## Seismic Walkdown Checklists (SWCs)

Table C-1 Summary of Seismic Walkdown Checklists for DCCNP1 Online Walkdowns			
COMPONENT ID	DESCRIPTION	Anchorage Verification Confirmed	PAGE
12-CRV-51	UNIT 1 & UNIT 2 CONDENSATE STORAGE TANKS CROSSTIE	N	C-5
12-HE-16N	Spent Fuel Pit Heat Exchanger (Note: This is the only SWEL2 Component included)	Y	C-8
12-HV-ACCP-3	COMPONENT COOLING WATER PUMPS VENTILATION SOUTH	N	C-10
12-HV-ESW-5	UNIT 1 WEST ESW PP ROOM SUPPLY VENTILATION FAN	Y	C-13
1-ABD-A	600VAC MOTOR CONTROL CENTER ABD-A	Y	C-19
1-ABD-B	600VAC MOTOR CONTROL CENTER ABD-B	N	C-28
1-ACRA-2	CONTROL ROOM AIR HANDLING SUBPANEL #2	Y	C-37
1-AM-A	600VAC MOTOR CONTROL CENTER AM-A	Y	C-44
1-BATT-AB	PLANT BATTERY AB	Y	C-49
1-BC-AB	PLANT BATTERY BATT-AB CONTROL PANEL	Y	C-54
1-BC-AB1	PLANT BATTERY BATT-AB BATTERY CHARGER #1	Y	C-59
1-BC-AB2	PLANT BATTERY BATT-AB CHARGER #2	N	C-65
1-BCTC-AB <sup>(1)</sup>	PLANT BATTERY CHARGERS BC-AB1 AND BC-AB2 TRANSFER	Y	C-71
1-BLI-130	STEAM GENERATOR OME-3-3 WIDE RANGE LEVEL INDICATOR TRANSMITTER	Y	C-75

Project: DC Cook 1 SWEL

Equipment ID No.: 12-CRV-51

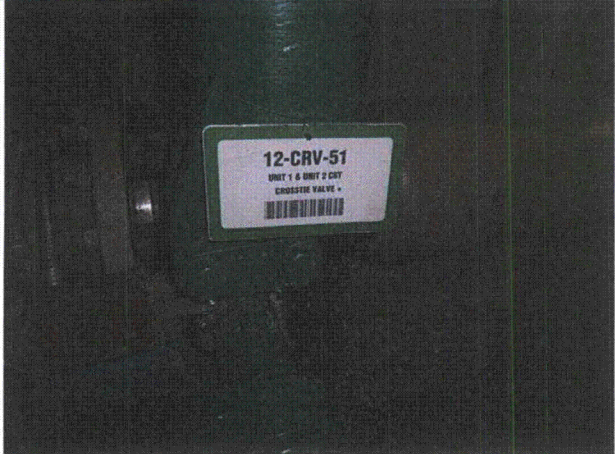
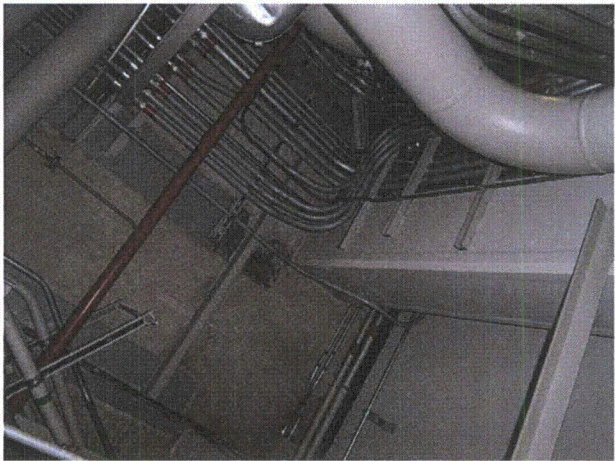
| 7. Are soft targets free from impact by nearby equipment or structures?<br><i>Fire extinguishers on short hooks cannot impact valve and therefore this was acceptable for this component. - AR 2012-11669 was issued.</i> | Yes |  |

Equipment ID No.: 1-ABD-A

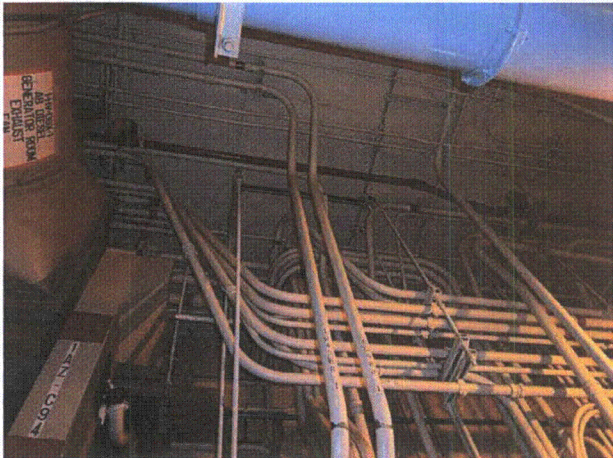
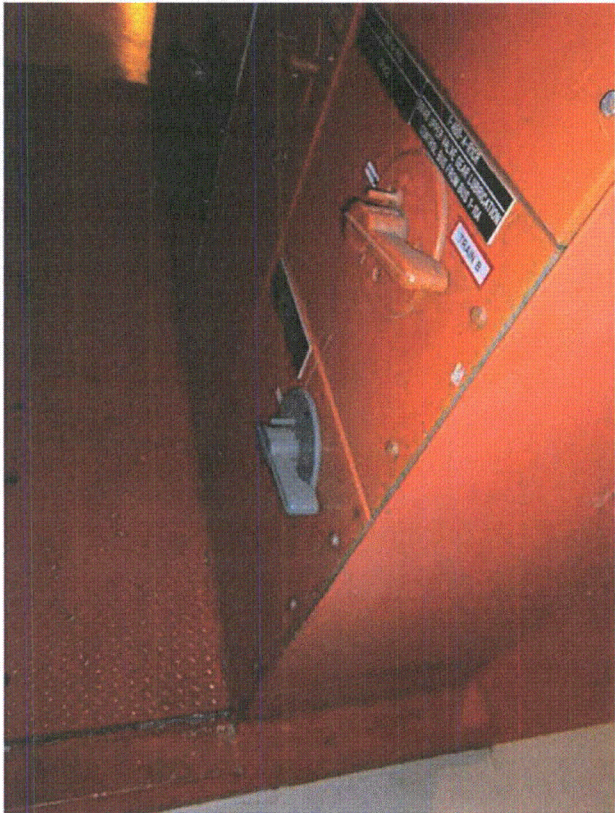
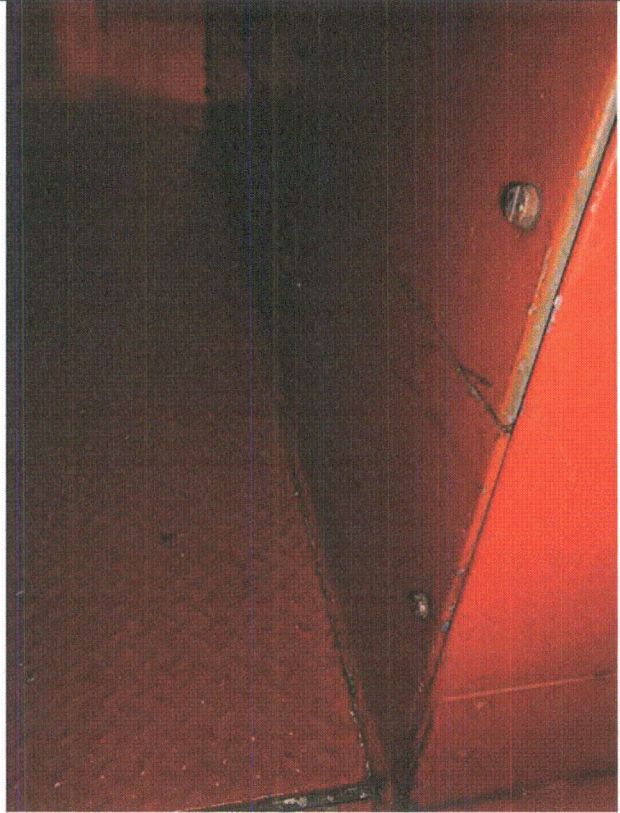
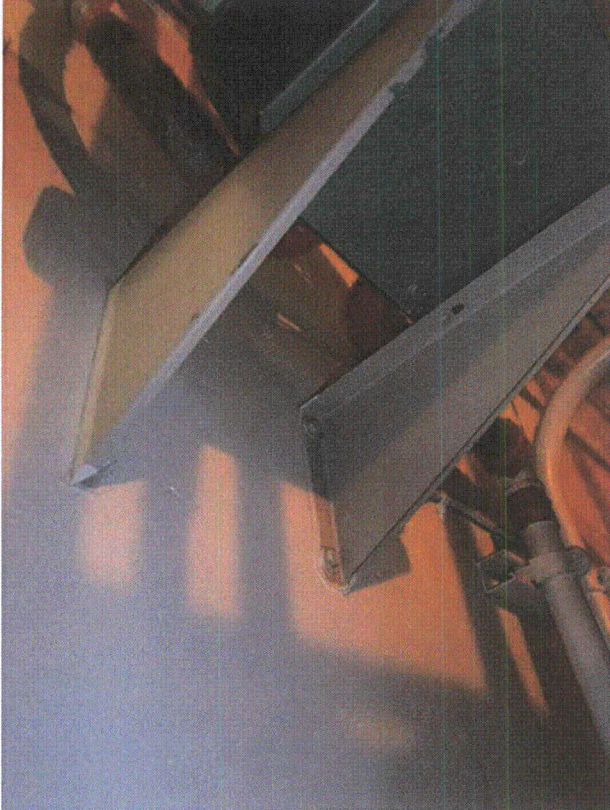
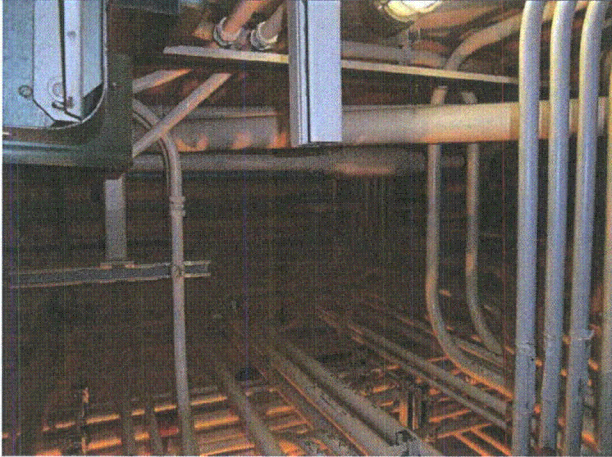
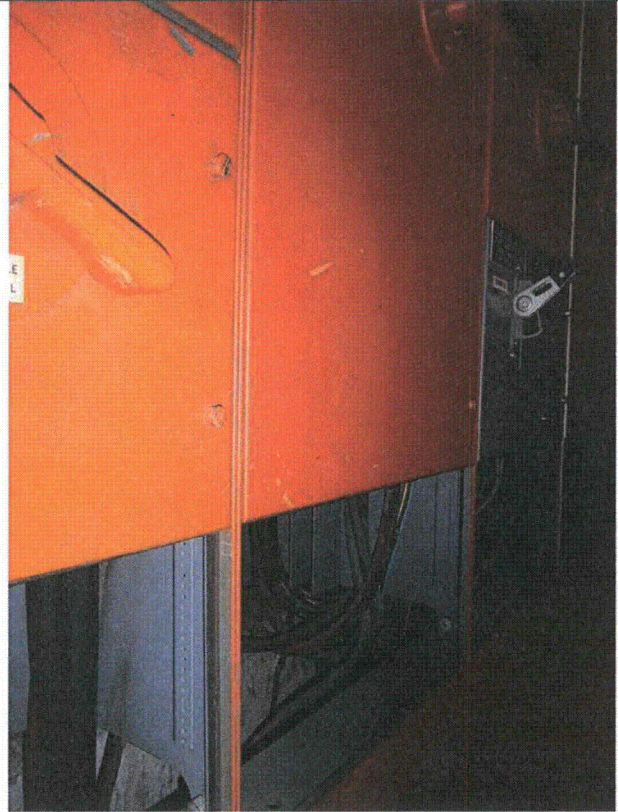
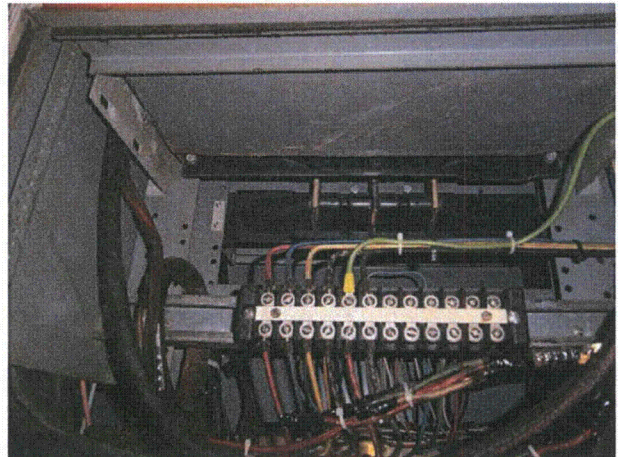
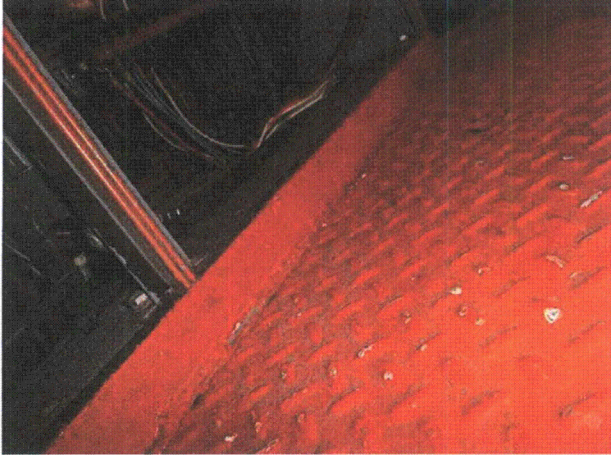
7. Are soft targets free from impact by nearby equipment or structures? No  
*Fire extinguishers on short hooks - AR 2012-11669 was issued.*
8. Are overhead equipment, distribution systems, ceiling tiles and lighting, and masonry block walls not likely to collapse onto the equipment? Yes  
*CO2 fire protection*
9. Do attached lines have adequate flexibility to avoid damage? Yes
10. Based on the above seismic interaction evaluations, is equipment free of potentially adverse seismic interaction effects? No

Equipment ID No.: 1-ABD-B

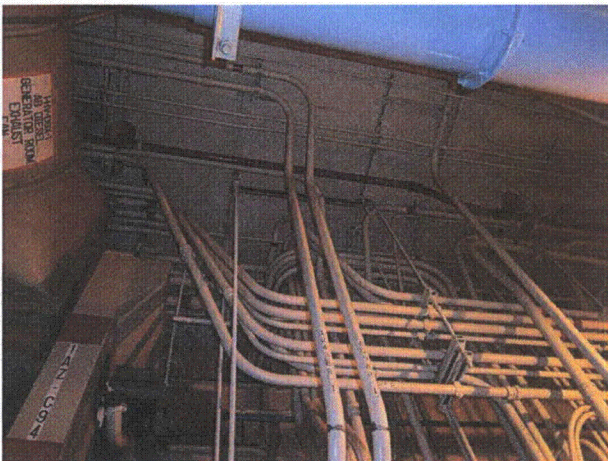
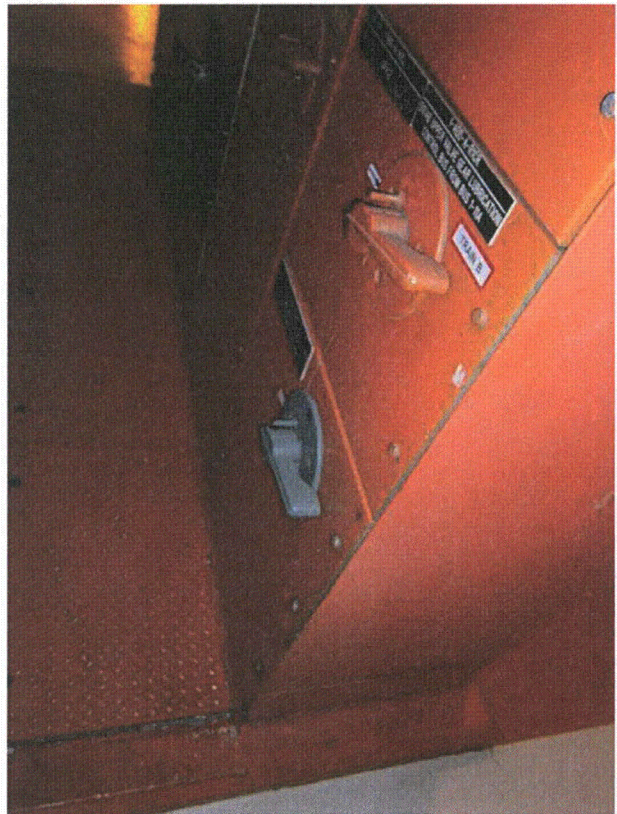
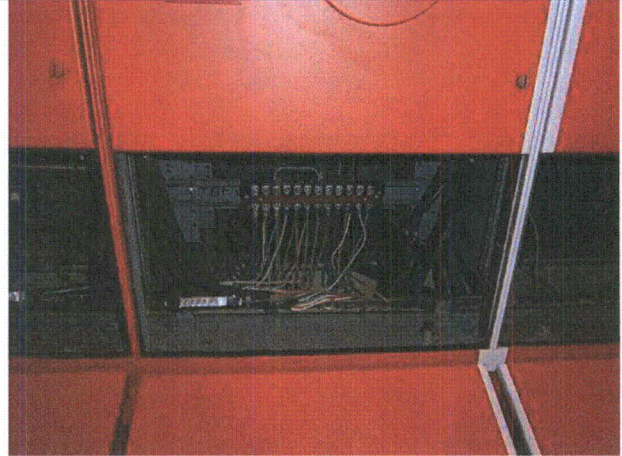
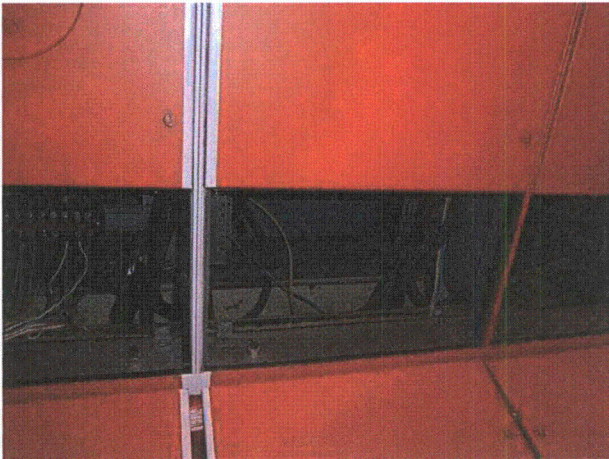
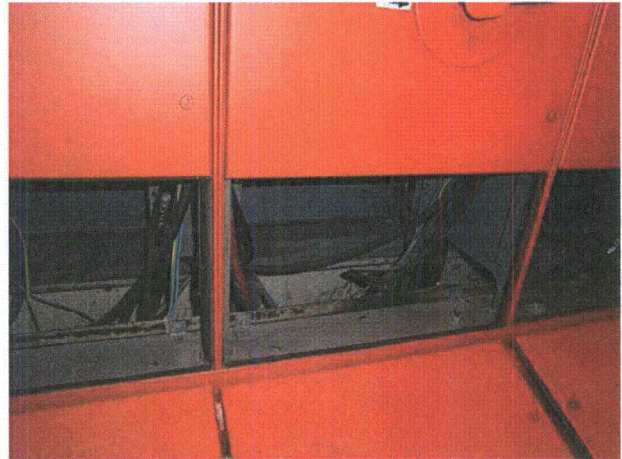
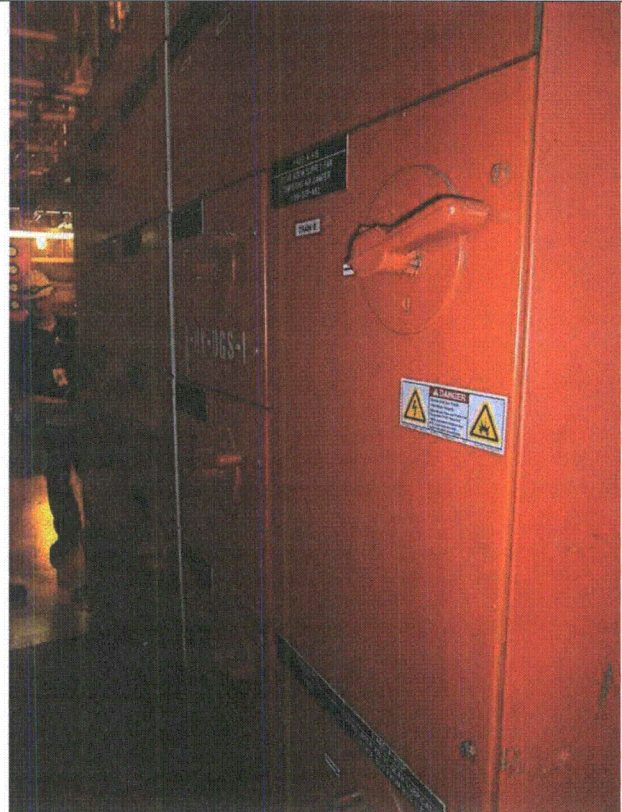
7. Are soft targets free from impact by nearby equipment or structures? No  
*Fire extinguishers on short hooks - AR 2012-11669 was issued.*
8. Are overhead equipment, distribution systems, ceiling tiles and lighting, and masonry block walls not likely to collapse onto the equipment? Yes  
*CO2 fire protection*
9. Do attached lines have adequate flexibility to avoid damage? Yes
10. Based on the above seismic interaction evaluations, is equipment free of potentially adverse seismic interaction effects? No
